Application No.	Applicant(s)	
		10/684,684	YAMANAKA ET AL.	
	Office Action Summary	Examiner	Art Unit	
		Ernesto Garcia	3679	
Period fo	The MAILING DATE of this communication app or Reply	ears on the cover sheet with the c	correspondence address	
A SH WHIC - Exte after - If NC - Failu Any	ORTENED STATUTORY PERIOD FOR REPLY CHEVER IS LONGER, FROM THE MAILING DANSIONS of time may be available under the provisions of 37 CFR 1.13 SIX (6) MONTHS from the mailing date of this communication. Of the maximum statutory period we are to reply within the set or extended period for reply will, by statute, reply received by the Office later than three months after the mailing ed patent term adjustment. See 37 CFR 1.704(b).	ATE OF THIS COMMUNICATION 36(a). In no event, however, may a reply be tir vill apply and will expire SIX (6) MONTHS from 1. cause the application to become ABANDONE	N. nely filed the mailing date of this communication. D. (35 U.S.C. § 133)

DETAILED ACTION

Fig. 8.

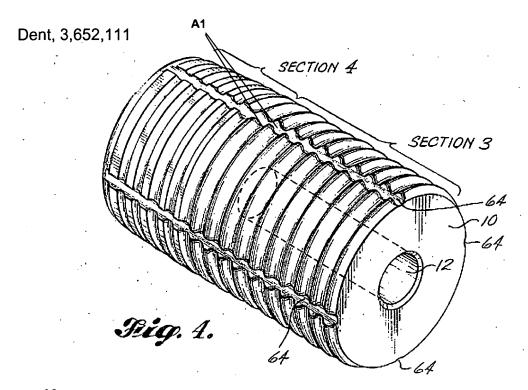
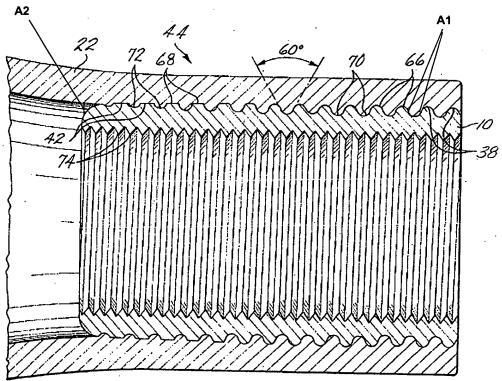
first material (col. 1, lines 18-24). The shaft member 10 has an outer periphery formed with an axial groove 64 and a circumferential groove 36 (see Figure 3). The axial groove 64 and the circumferential groove 36 have a cross-section having opposed faces A1 (see marked-up attachment) substantially parallel to each other. The cylindrical member 22 is fitted to the outer periphery of the shaft member 10. The cylindrical member 22 is formed out of a second material greater in linear expansion coefficient than the first material (col. 1, lines 18-24). A caulked portion (not shown; see col. 6, lines 29-34) is provided to the cylindrical member 22 at an intersection of the axial groove 64 and the circumferential groove 36. The caulked portion has a continuous and deformed inner surface in press contact with the opposed faces A1 of the axial groove 64 and the circumferential groove 36. The axial groove 64 is greater in

Regarding claim 9, the cylindrical member 22 is apart from the shaft member 10 by a clearance A2 except at the caulked portion 18.

The axial groove **64** has a cross-section having opposed faces **A1** (see marked-up attachment) substantially parallel to each other. The cylindrical member **22** is provided to the outer periphery of the shaft member **10**. The cylindrical member **22** is formed out of a second material greater in linear expansion coefficient than the first material (col. 1, lines 18-24). A caulked portion (not shown; see col. 6, lines 29-34) is provided to the cylindrical member **22** at a position corresponding to the axial groove **64** of the shaft member **10**. The caulked portion has a deformed inner surface in press contact with the opposed faces **A1** of the circumferential groove **36**. The cylindrical member **22** is spaced apart from the shaft member **10** by a clearance **A2** except at the caulked portion.
